Mack - North Phase (49-DR-2022#2)  
**Summary of Updates from Prior Submittal**

# MACK INNOVATION PARK

PHASE 1 - North

SEC of Loop 101 and Pima Road  
Development Review Application  
Application 49-DR-2022#2

1 BLDG D - NORTH ELEVATION  
SCALE: 1" = 30'-0"

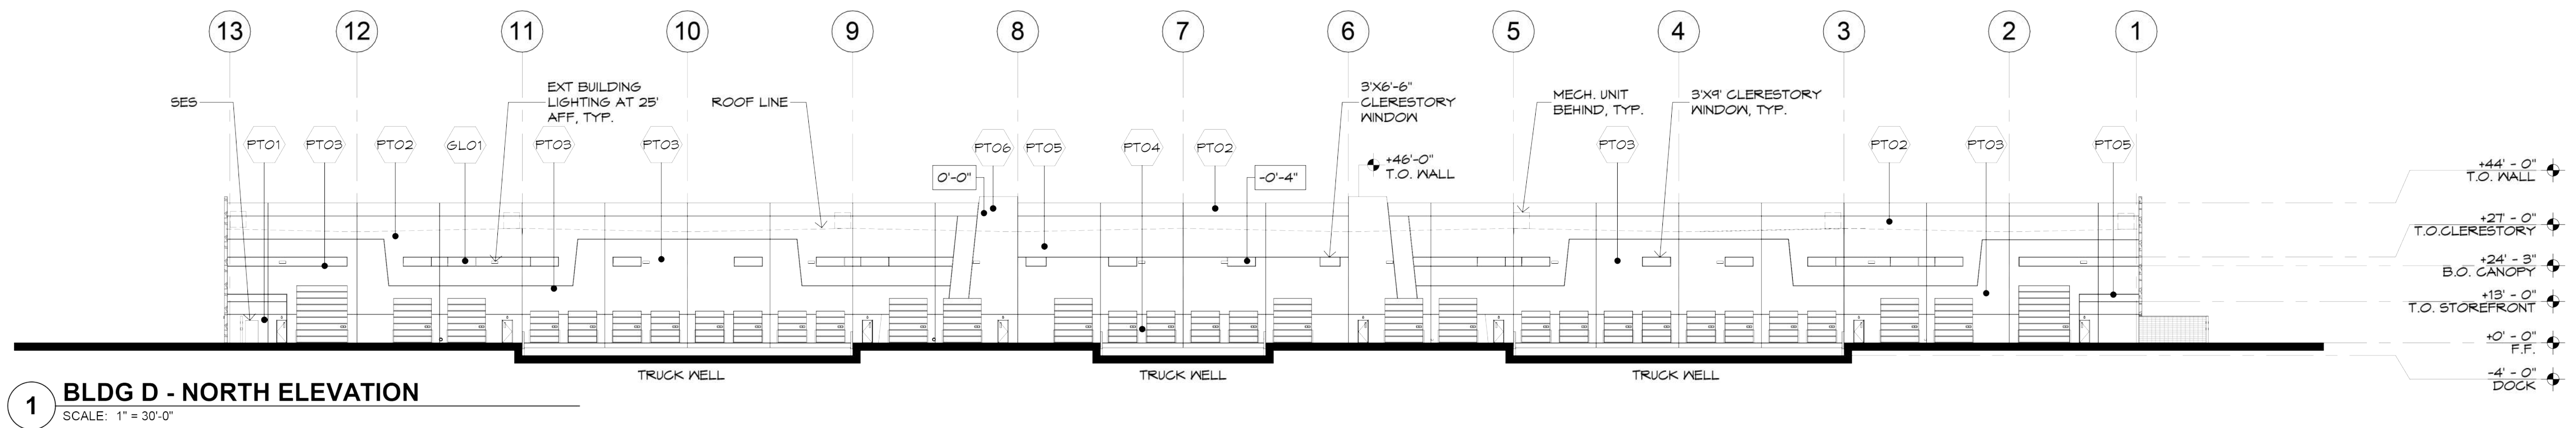
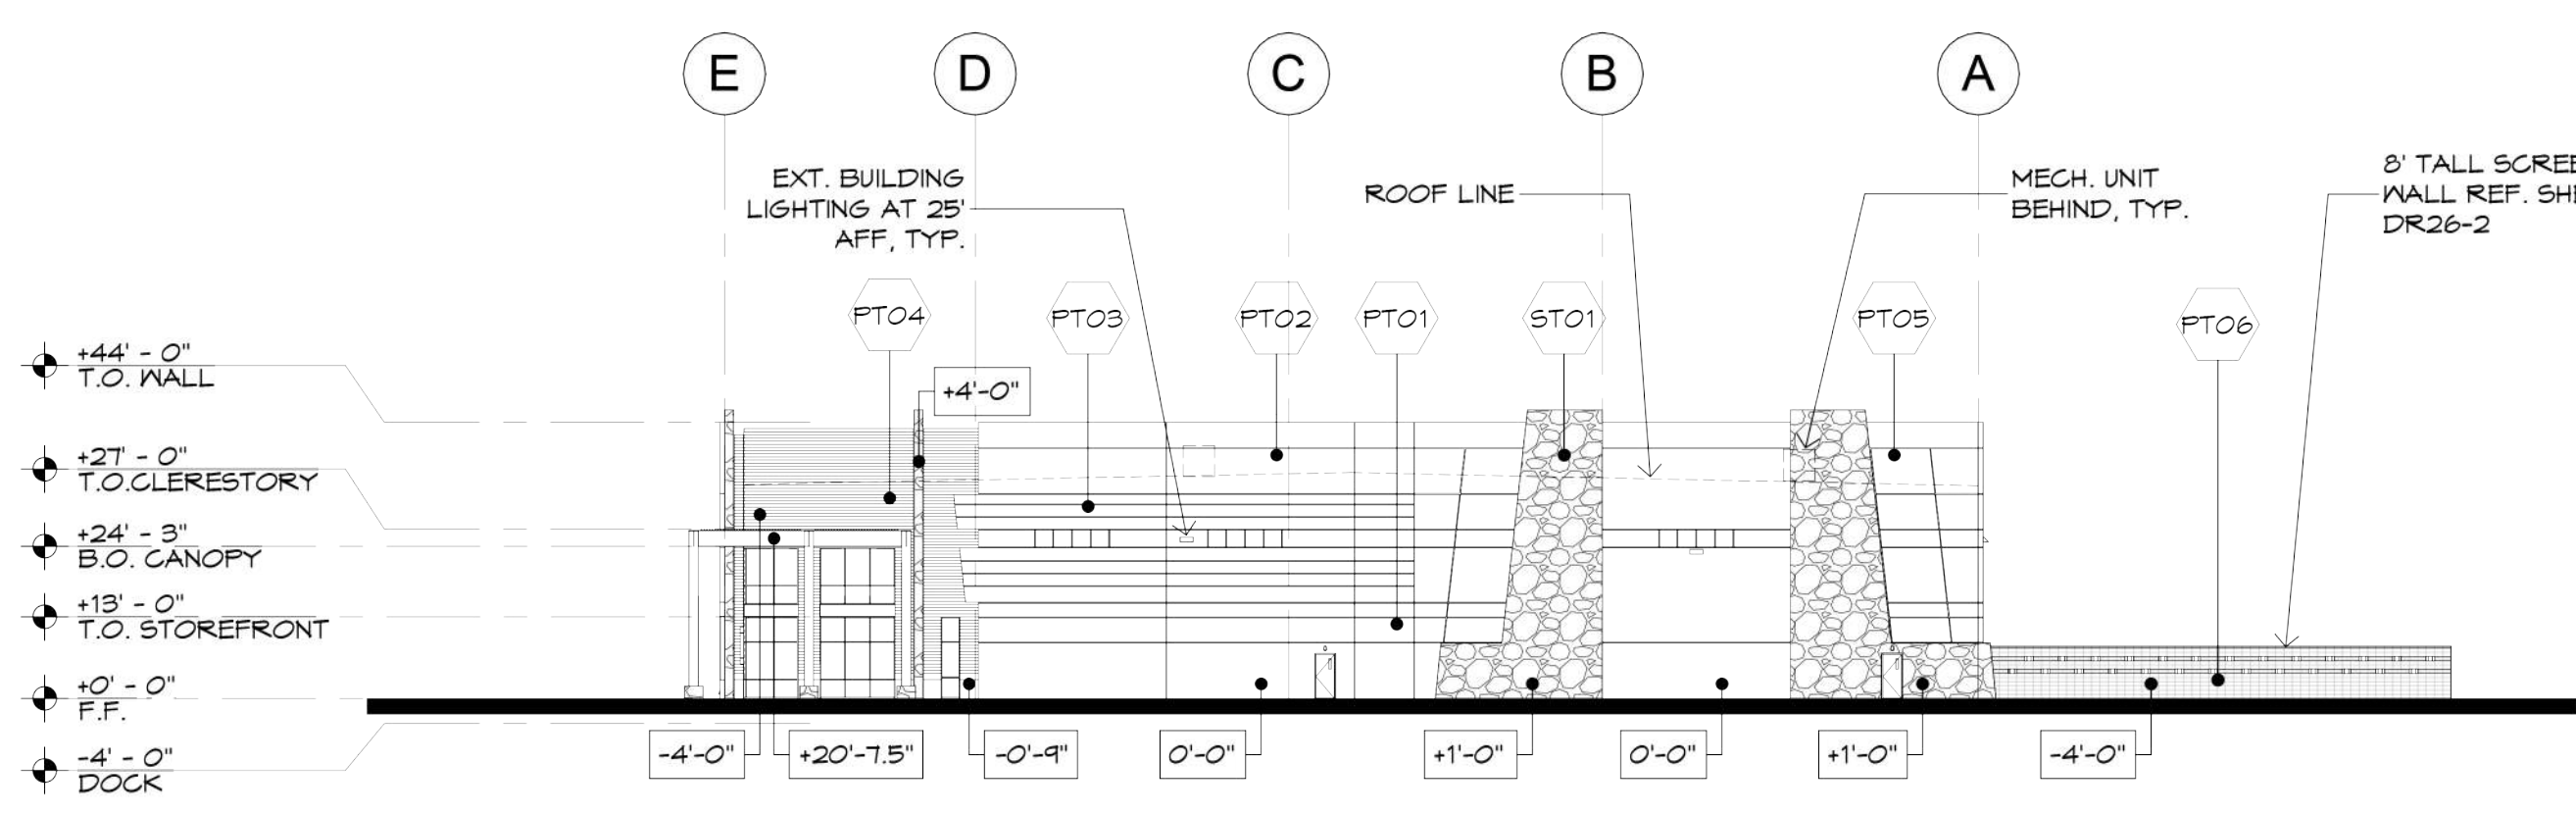
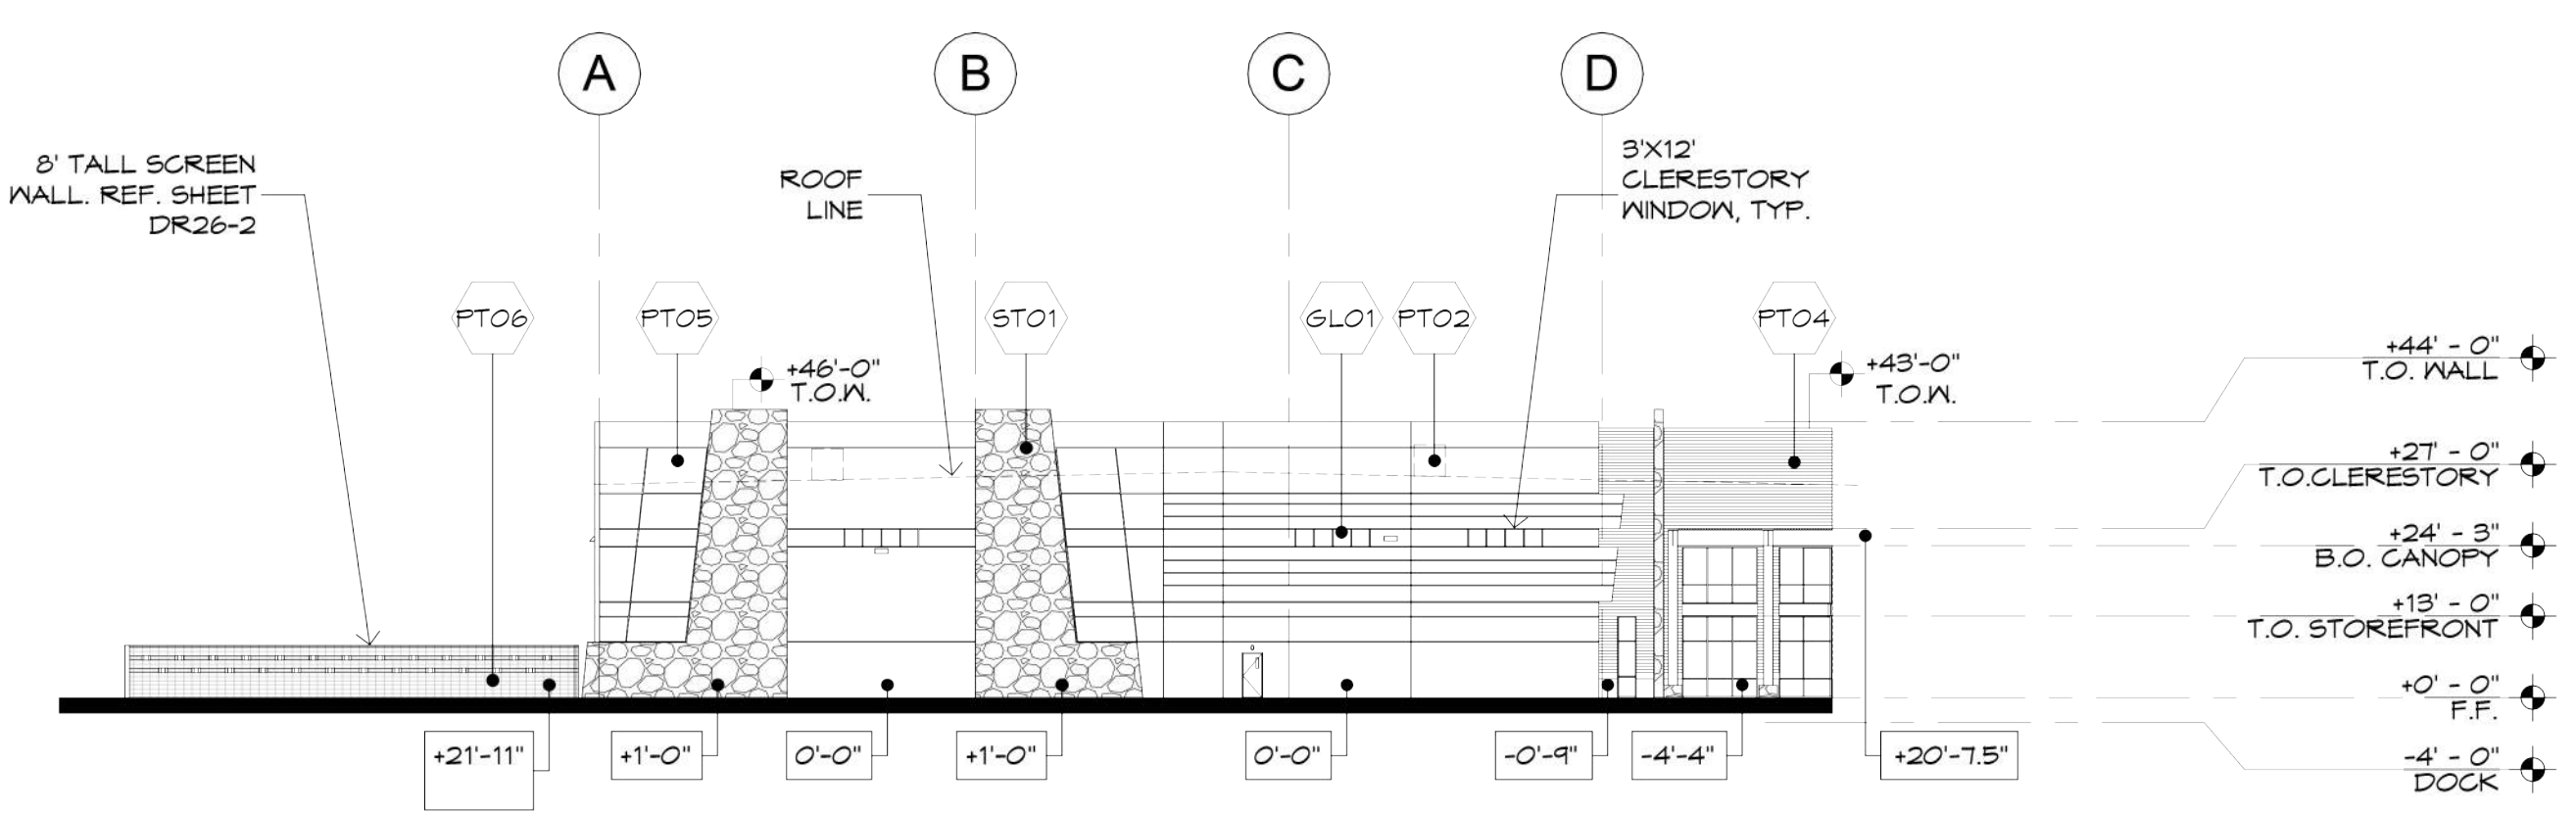
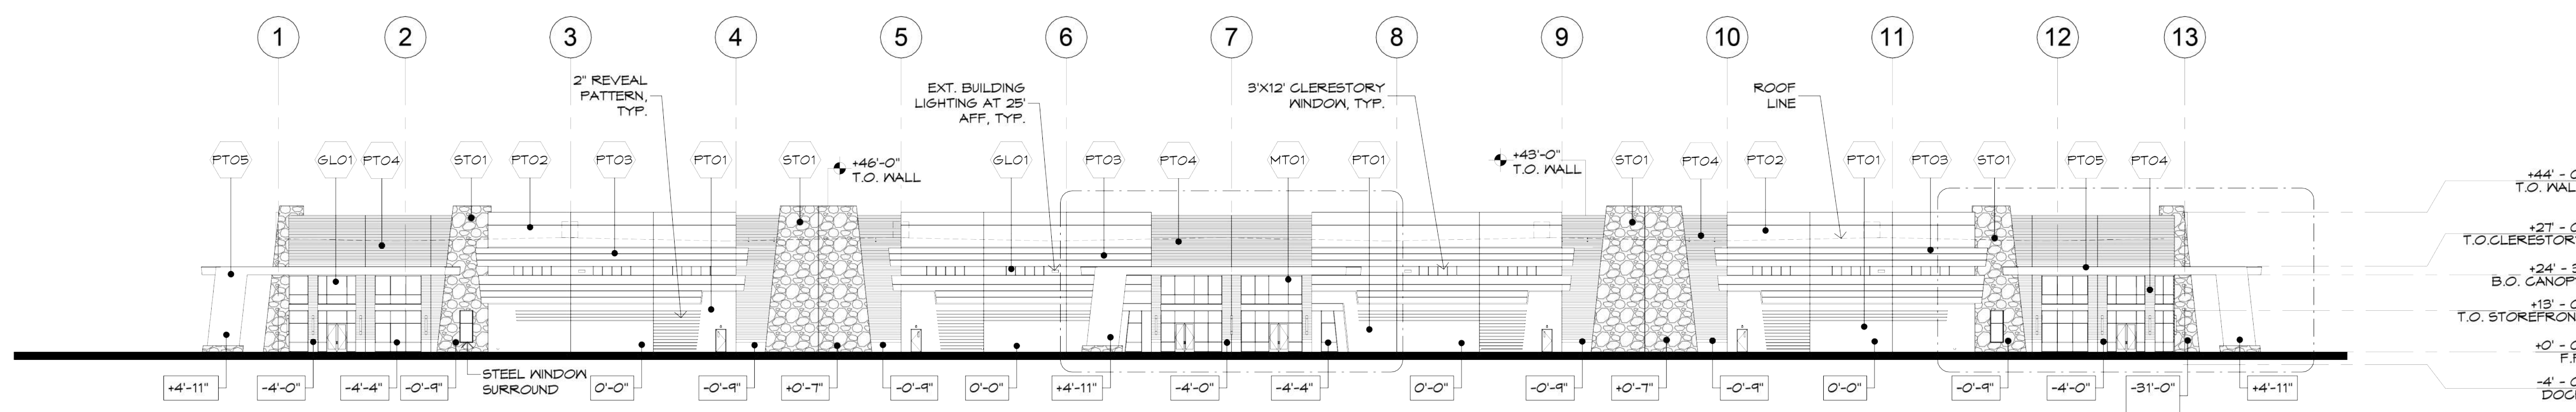
DR39 Revised B&W and Color Elevations

- Updated to show revised building exterior colors and loading dock elevations with added architectural details
